TITEL: Kontroll av stjärtrotorväxel för avsaknad av låskil.

GÄLLER: Modell R22 med installerad växel tillverkad eller översedd av Robinson Helicopter Company före 8 juni 1992, undantaget växlar med S/N angivna i bifogad kopia av FAA AD 95-23-05.

LFS: 1995:69

95-23-05 ROBINSON HELICOPTER COMPANY: Amendment 39-9425. Docket No. 95-SW-06-AD. Supersedes AD 94-17-07, Amendment 39-9059.

Figure 1

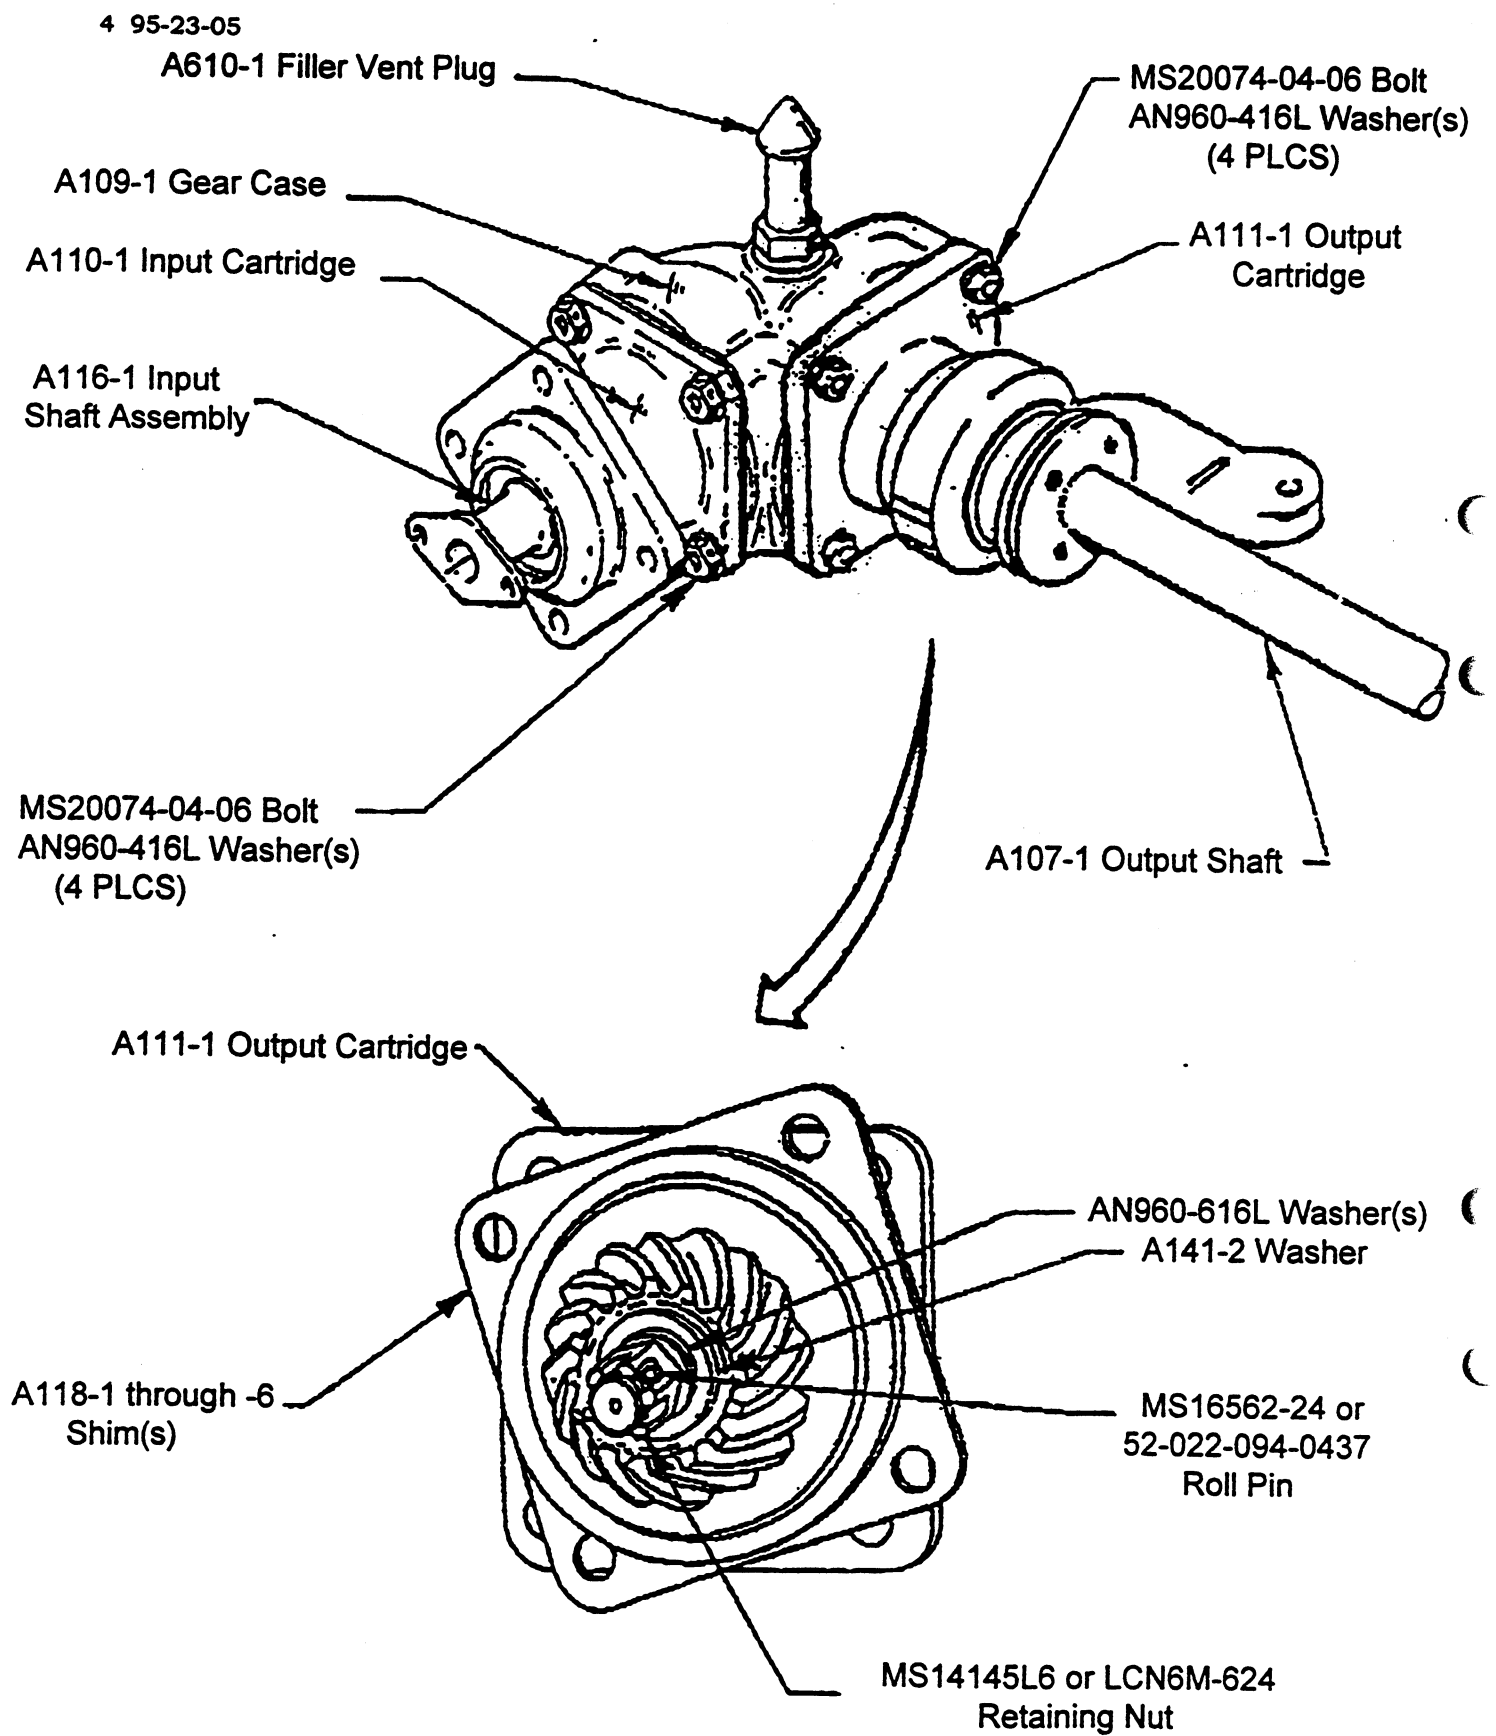
(4) Remove and disassemble the output cartridge, P/N A111-1, from the T/R gearbox case, P/N A109-1 (see figure 1) as follows:

(ii) Cut and remove the safety wire around the four MS20074-04-06 bolts securing the output cartridge to the gear case. Remove and retain each of the four bolts and their associated AN960-416L washer(s), noting the washer stacks for reassembly. Separate the output cartridge from the gear case (see figure 1).

(ii) Cut and remove the safety wire around the four MS20074-04-06 bolts securing the input cartridge to the gear case. Remove each of the four bolts and their associated AN960-416L washer(s), noting the washer stacks for reassembly. Separate the input cartridge from the gear case (see figure 1).

(iii) Secure the input cartridge to a block of wood through the two bolt holes in the input shaft assembly, P/N A116-1 (see figure 1). Place the block of wood in a vise. Remove and discard the safety wire, roll pin, and retaining nut. Remove the AN960-616L washer(s), and washer, P/N A141-1, noting the washer(s) location for reassembly. Do not damage the input shaft or shim(s), P/N A118-1 through -6, located next to the flange of the input cartridge.

Figure 2

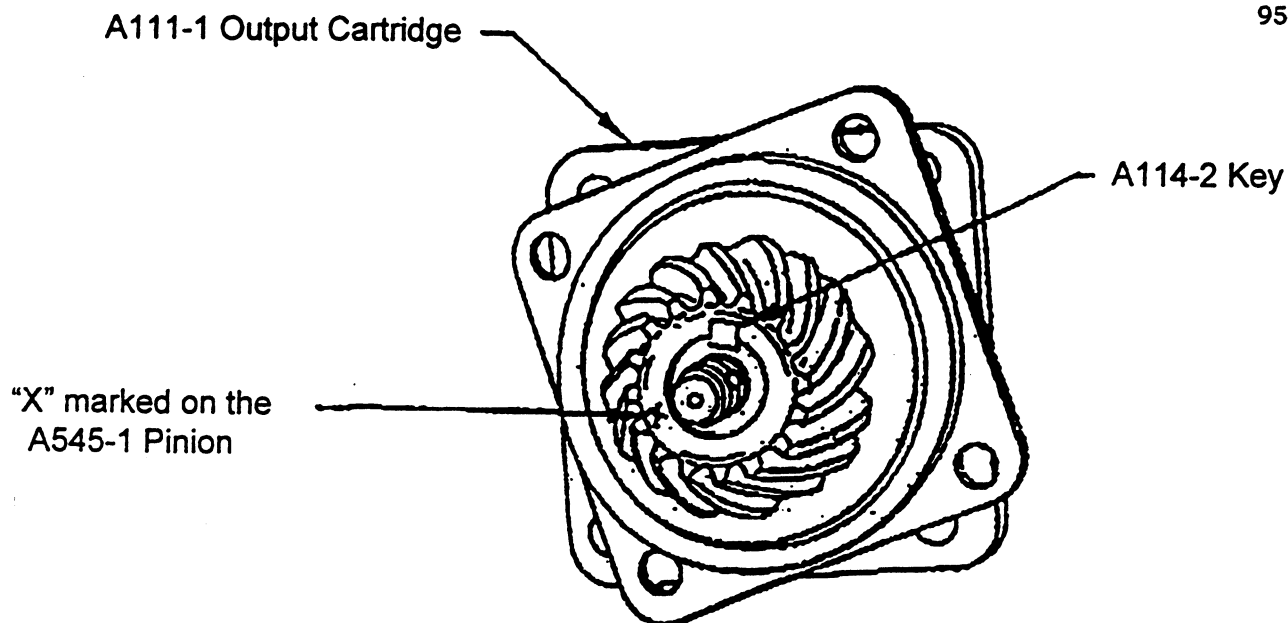
(iv) Visually inspect for the presence of the output shaft key, P/N A114-2, between the pinion gear, P/N A545-1, and the output shaft (see figure 2).

(iv) Visually inspect for the presence of the input shaft key, P/N A114-1, between the gear, P/N A545-2, and the input shaft (see Note on figure 2).

(v) If the output shaft key is missing, replace the T/R gearbox with an airworthy gearbox that has been determined to have the output key installed. Report any T/R gearbox that has a missing key within 10 days after the inspection to the Manager, Los Angeles Manufacturing Inspection Office, FAA, Northwest Mountain Region, 3960 Paramount Blvd., Lakewood, California 90712, telephone (310) 627-5290, fax (310) 627-5293. Reporting requirements have been approved by the Office of Management and Budget and assigned OMB control number 2120-0056.

(vi) If the output key is installed, reinstall the washer, P/N A141-2, and AN960-616L washer(s). Install an MS14145L6 or LCN6M-624 retaining nut, and torque to 225-275 in.-lbs. Install a MS16562-24 or 52-022-094-0437 roll pin, and safety wire using 0.032-inch stainless steel safety wire. The safety wire pigtail must be wrapped tightly around the retaining nut.

(v) If the input shaft key is missing, replace the T/R gearbox with an airworthy gearbox that has been determined to have the input key installed. Report any T/R gearbox that has a missing key within 10 days after the inspection to the Manager, Los Angeles Manufacturing Inspection District Office, FAA, Northwest Mountain Region, 3960 Paramount Blvd., Lakewood, California 90712, telephone (310) 627-5290, fax (310) 627-5293. Reporting requirements have been approved by the Office of Management and Budget, and assigned OMB control number 2120-0056.

(vi) If the input key is installed, reinstall the AN960-616L washer(s) and washer, P/N A141-1. Install an MS14145L6 or LCN6M-624 retaining nut, and torque to 225-275 in.-lbs. Install a MS16562-24 or 52-022-094-0437 roll pin and safety wire using 0.032-inch stainless steel safety wire. The safety wire pigtail must be wrapped tightly around the retaining nut. Remove the two bolts securing the input shaft assembly to the block of wood. Vibro-etch the final rule AD number on the input cartridge attachment flange.

Figure 3

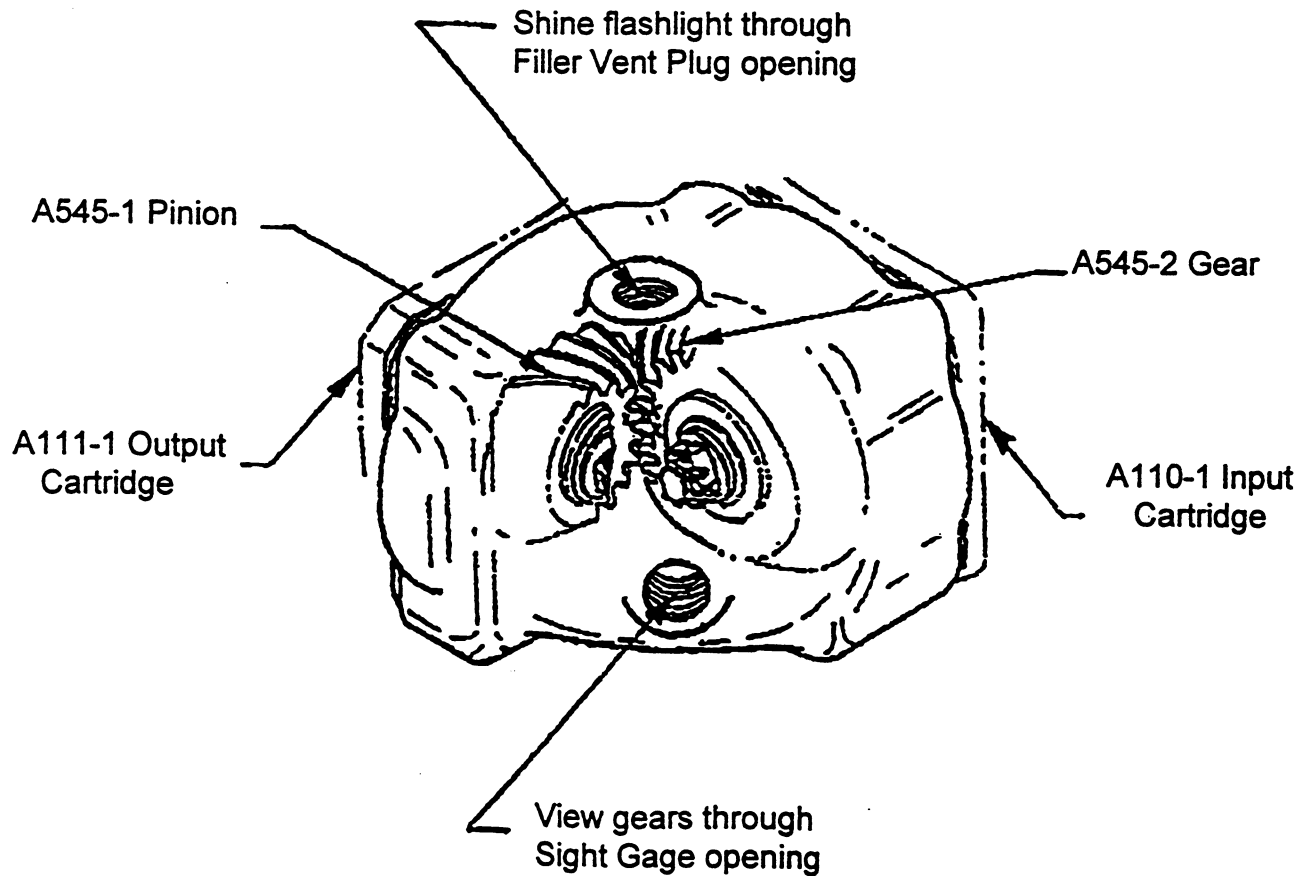
(i) Color the "X" marked on the pinion gear, P/N A545-1, (one tooth only) of the output cartridge and on the gear, P/N A545-2, (located on two consecutive teeth) of the input cartridge with a red marker to make reinstallation easier. Note that these three gear teeth may already be colored (see figure 3).

(v) Look through the sight gage opening while using a flashlight pointed into the filler vent hole to verify the gears are meshed properly. Gears are properly meshed when the "X" marked on the pinion gear of the output cartridge is between the two "X's" marked on the gear of the input cartridge (see figure 3). Do not torque the MS20074-04-06 bolts until both cartridges are installed on the case and the gears are properly meshed. Torque the output cartridge bolts to 60 in.-lbs. first, then torque the input cartridge bolts to 60 in.-lbs. Safety wire with 0.032-inch stainless steel safety wire.

Figure 4

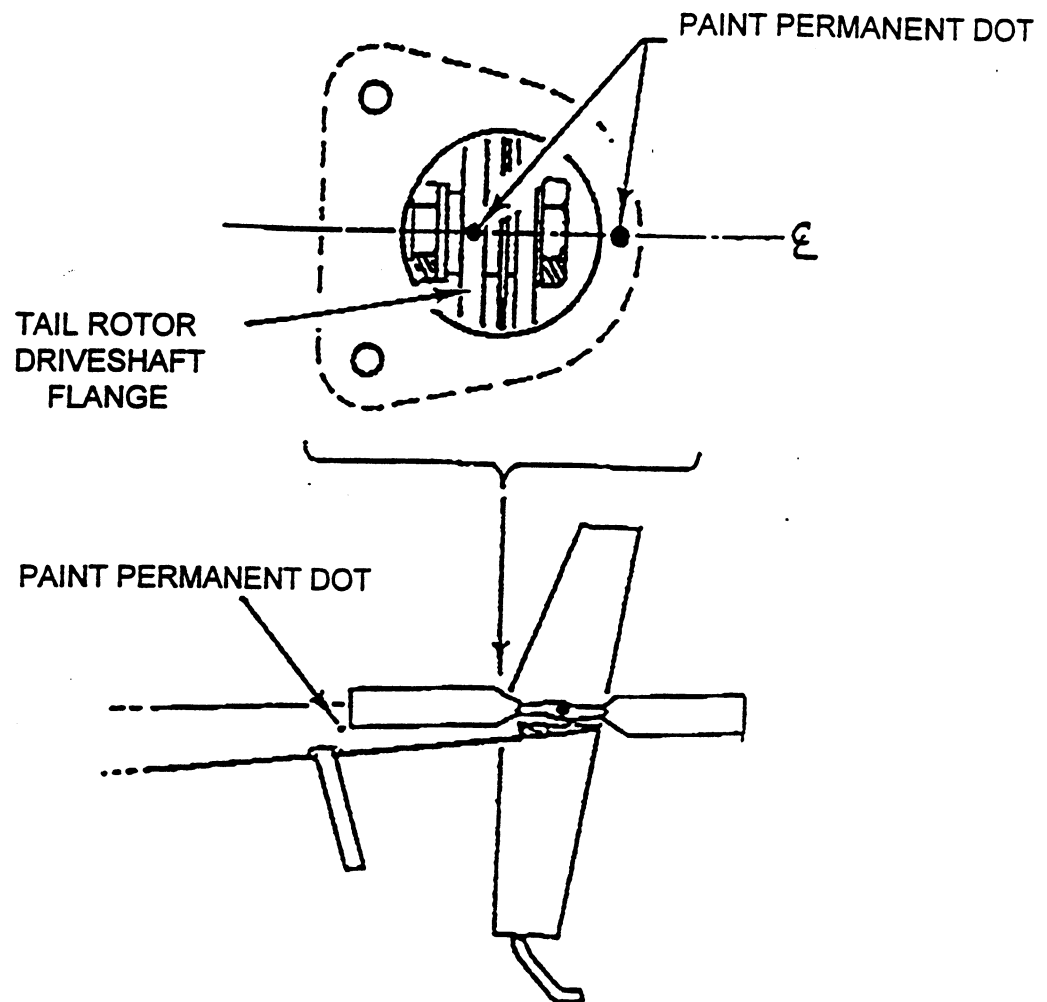
(a) Before further flight, install alignment dots as follows: Remove the transparent inspection cover on the tail cone and rotate the T/R blades so that one blade leading edge is aligned with the tail cone centerline. Mark a dot on the tail cone skin aligned with the tip of the blade leading edge. With the same alignment, mark a dot on the centerline of the tail cone skin at the edge of the inspection hole, and mark a corresponding dot on the drive shaft flange (see figure 4).

(b) Conduct the following daily preflight checks for misalignment of the alignment dots until compliance with paragraph (c) of this AD has been accomplished: Check for misalignment of the alignment dots installed on the tail cone skin and the drive shaft flange by rotating the T/R blade so that the alignment dot is visible in the inspection window and the tip of the T/R blade leading edge aligns with the dot on the tail cone skin. Ensure that the drive shaft flange dot is aligned with the dot on the centerline of the tail cone skin at the edge of the inspection window. If any misalignment is detected, before further flight, replace the T/R gearbox with an airworthy one that has been determined to have both the input and output keys installed in accordance with paragraph (c) of this AD or other FAA-approved procedures, or is exempt from the requirements of this AD as listed in the applicability section of this AD. The daily preflight checks required by this AD may be performed by an owner/operator holding at least a private pilot certificate and must be entered into the aircraft records showing compliance with paragraph (b) of this AD, in accordance with sections 43.11 and 91.417(a)(2)(v) of the Federal Aviation Regulations.
